DEPARTMENT OF CITY PLANNING RECOMMENDATION REPORT

Case No.: CPC-2016-1812-SP-SPP CEQA No.: ENV-2016-1813-CE

PROJECT 1175 North Madison Avenue, legally described as Rose Hill Tract, Block None, Lots 32 and 33 LOCATION: (Arb 1 and 2).

The proposed project was reviewed by the Department of City Planning Urban Design Studio's Professional Volunteer Program (PVP) on July 19, 2016. Listed below are issues, concerns and recommendations that were discussed followed by project modifications and/or the applicant's justification as to why the PVP's recommendations could not be satisfied.

Shade Structure North Face Elevation

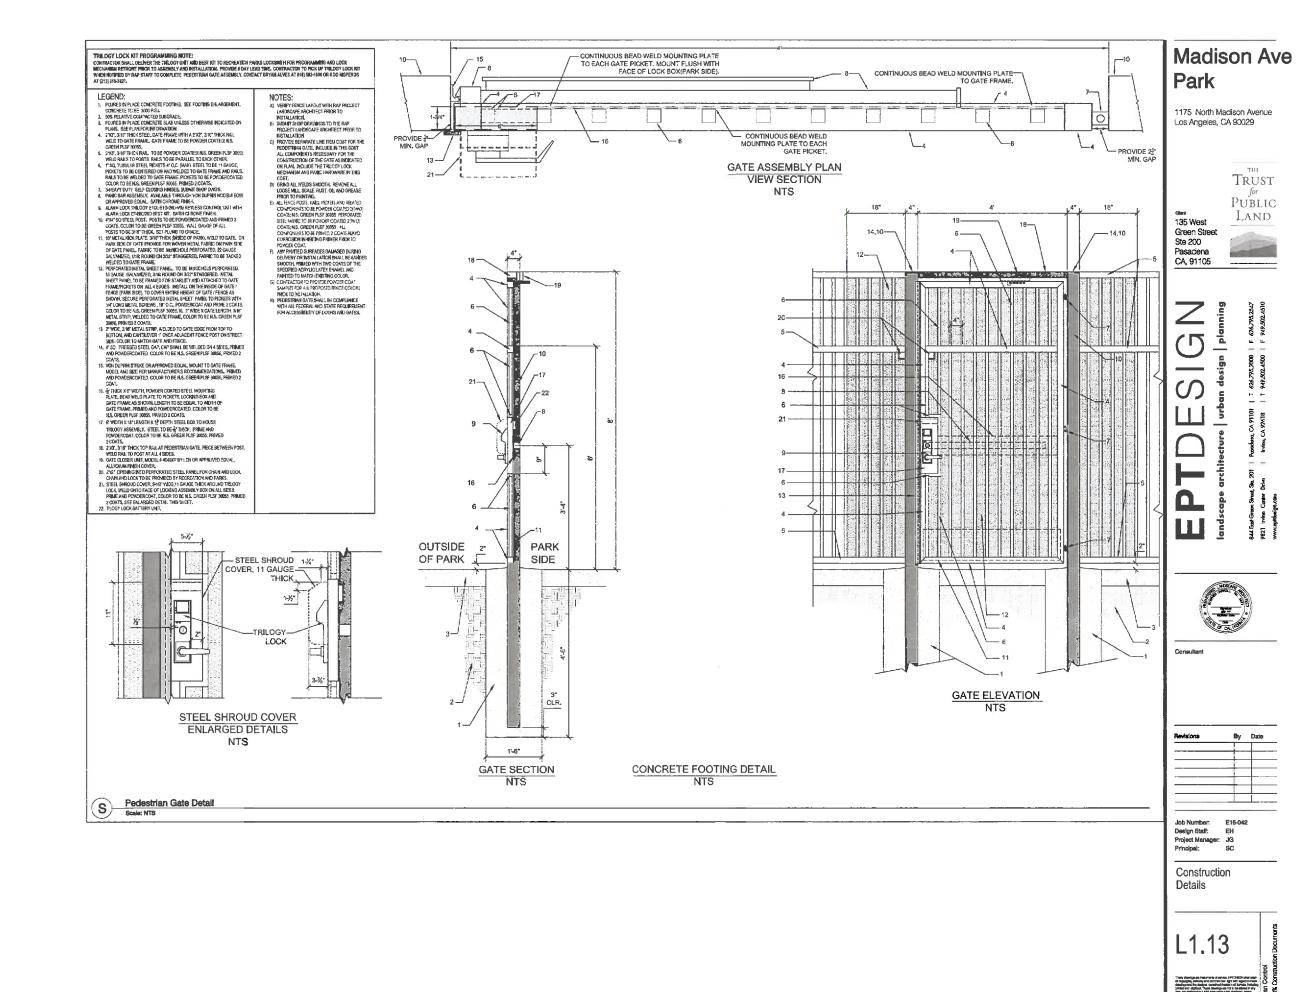
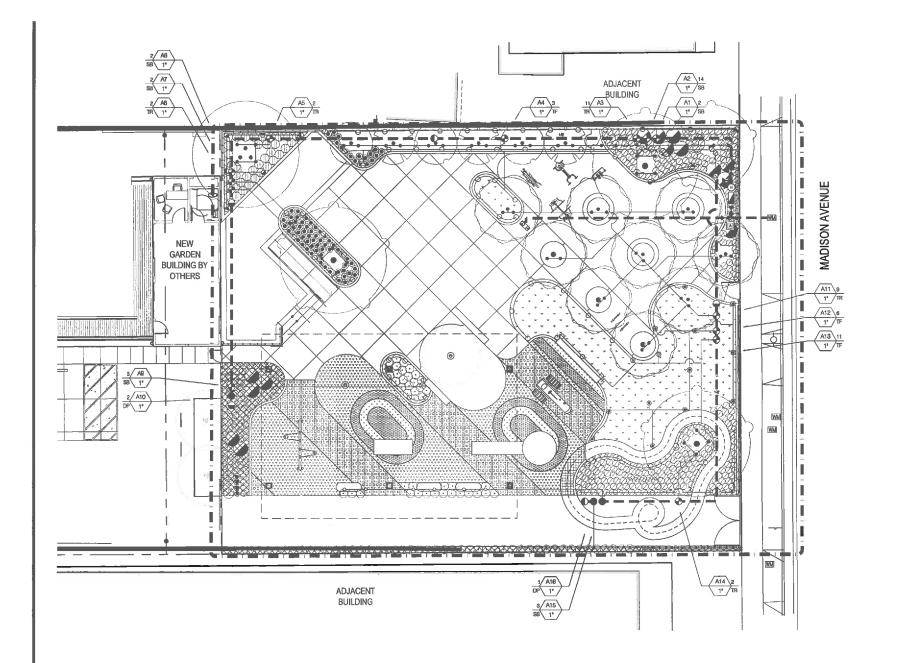
<u>PVP:</u> The design of the shade structure does not match the style and concept of the park as proposed in the illustrative site plan.

Response: The project representative stated that the design concept of the park references the agrarian aspect of the community garden. The design represents raw materials, angled roofs, and exposed structures used for sheds and packinghouses for production rather than a typical farm or barn and therefore cannot be redesigned.
